**RE: Murphy Express – Wyoming
1358 Wyoming Blvd
Permanent C.O. - Accepted
Engineer's Certification Dated 12/30/20
Engineer's Stamp Date: 01/12/18
Hydrology File: J20D037**

**RE: Murphy Express – Wyoming
1358 Wyoming Blvd
Temporary C.O. - Accepted
Engineer's Certification Dated 07/01/19
Engineer's Stamp Date: 01/12/18
Hydrology File: J20D037**

Project Murphy Oil - Albuquerque, NM
Project # 20161221.0
Re Hydrology Certification

HYDROLOGY CERTIFICATION

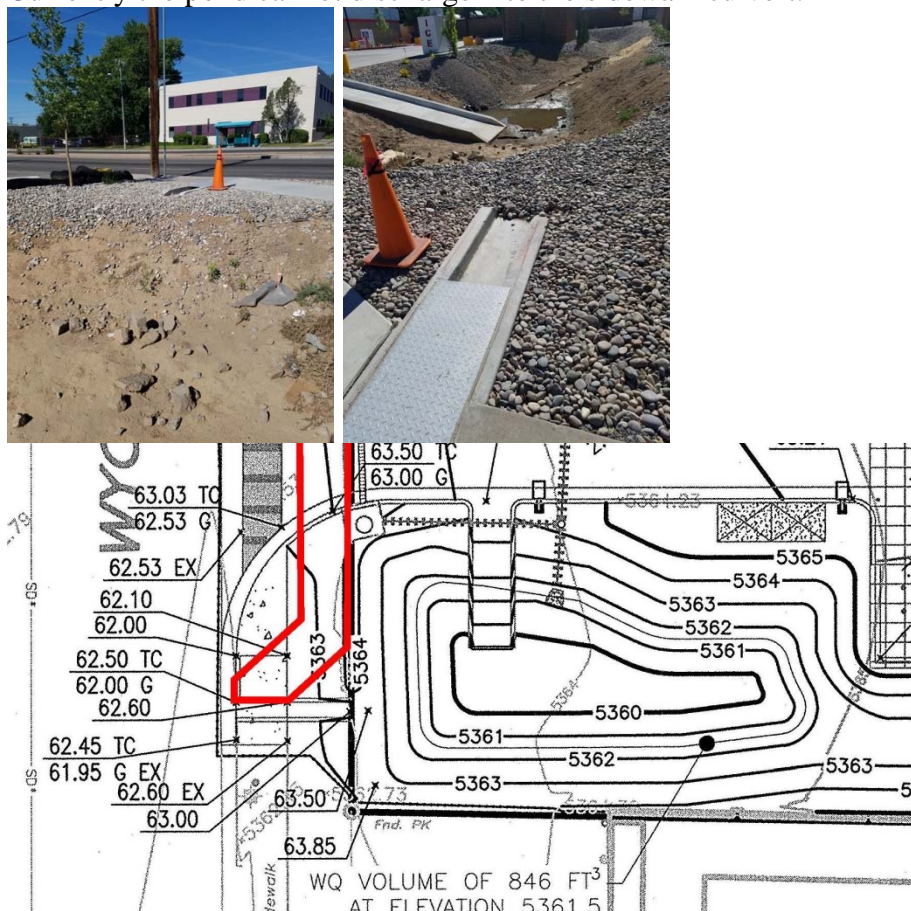
- Please finish installing the landscape rocks within the pond to stop erosion which is currently evident from the recent rainfall.

- The pond also needs to be reshaped at the outfall sidewalk culvert per the approved plans. Currently the pond cannot discharge into the sidewalk culvert.

AS-BUILT GRADING PLAN

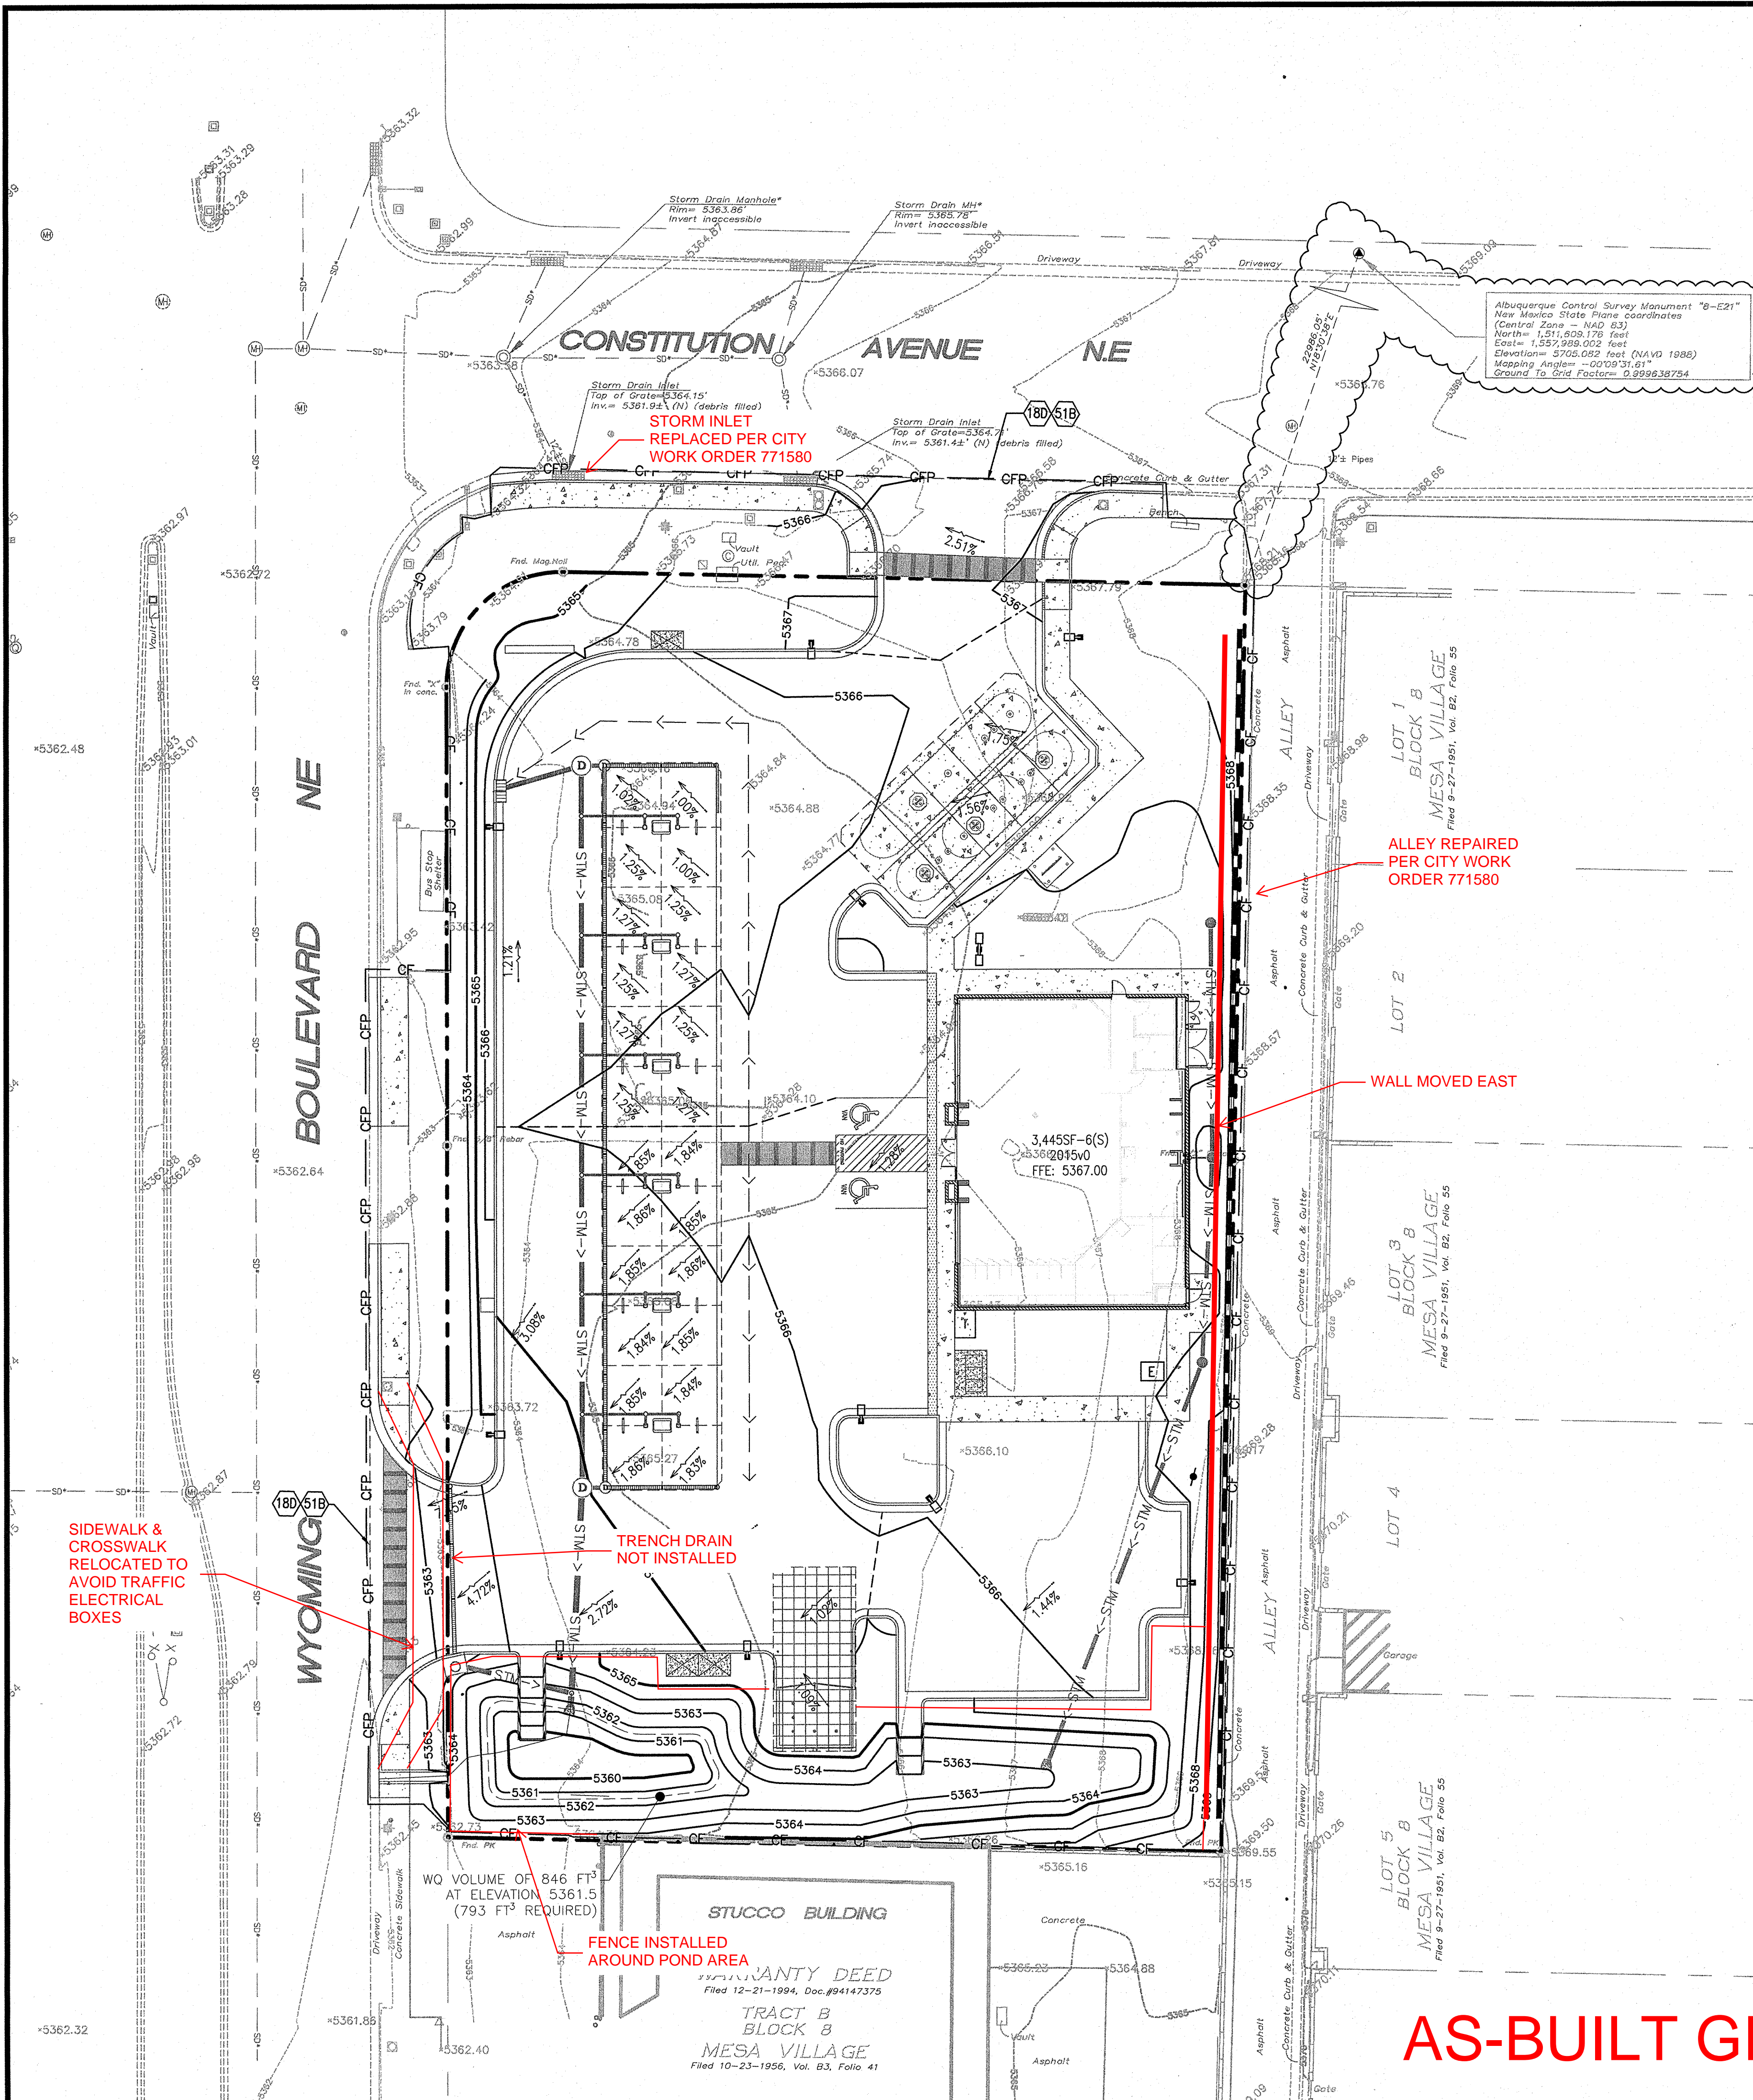
I, John Nourzad, NMPE 19062, OF THE FIRM GreenbergFarrow, HEREBY CERTIFY THAT THIS PROJECT HAS BEEN GRADED AND WILL DRAIN IN SUBSTANTIAL COMPLIANCE WITH AND IN ACCORDANCE WITH THE DESIGN INTENT OF THE APPROVED PLAN DATED 12/04/18, WITH THE EXCEPTION OF THE PROPOSED TRENCH DRAIN AT THE WYOMING BOULEVARD ENTRANCE WHICH WAS NOT INSTALLED. THE RECORD INFORMATION EDITED ONTO THE ORIGINAL DESIGN DOCUMENT HAS BEEN OBTAINED BY THE SITE AS-BUILT SURVEY PREPARED BY SURV-TEK CONSULTING SURVEYORS, DATED 12/31/19. I FURTHER CERTIFY THAT I HAVE REVIEWED SITE PICTURES OF THE PROJECT SITE AND HAVE DETERMINED BY VISUAL INSPECTION THAT THE INFORMATION PROVIDED IS REPRESENTATIVE OF ACTUAL SITE CONDITIONS AND IS TRUE AND CORRECT TO THE BEST OF MY KNOWLEDGE AND BELIEF. THIS CERTIFICATION IS SUBMITTED IN SUPPORT OF A REQUEST FOR CERTIFICATE OF OCCUPANCY.
